TO: City of Madison Plan Commission
FROM: Timothy Sobota, Transit Planner, Metro Transit
SUBJECT: 802 East Washington Avenue – Conditional Use – “The Galaxie”

TITLE: 802, 854 East Washington Avenue (800 North Block) – Mixed-Use Development with Commercial (Including a Grocery Store), Office and Residential Components in UDD No. 8. 2nd Ald. Dist. (32089)

Attached: Notated copy of Site plan, showing transit information,
Draft Station Plan View, from Madison Transit Corridor Study Document.

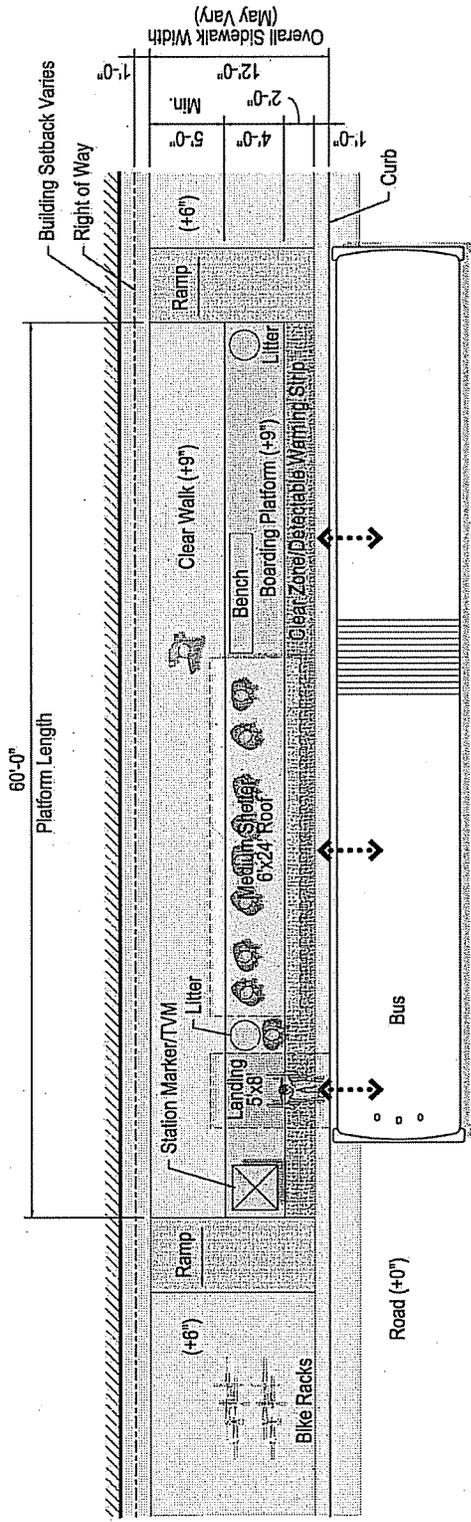
1. In coordination with public works improvements, the applicant shall maintain or replace the concrete passenger boarding pad at the existing Metro bus stop on the north side of East Washington Avenue, west of Paterson Street (#1660). The concrete pad shall occupy the full distance of the terrace, measure a minimum of 10 feet in width parallel to the street, and lie flush between the sidewalk and the top of curb. A continuous concrete terrace would also be suitable.

2. The applicant shall install and maintain a bench or other seating amenity in the adjacent property landscape plan, ideally taking advantage of any building overhang or canopy to provide the seating amenity some shelter from the elements.

3. The applicant shall maintain and protect access to the existing bus stop zone for both pedestrians and transit vehicles at all times during project construction.

4. The applicant shall include the location of these transit amenities on the final documents filed with their permit application so that Metro Transit may review and approve the design.
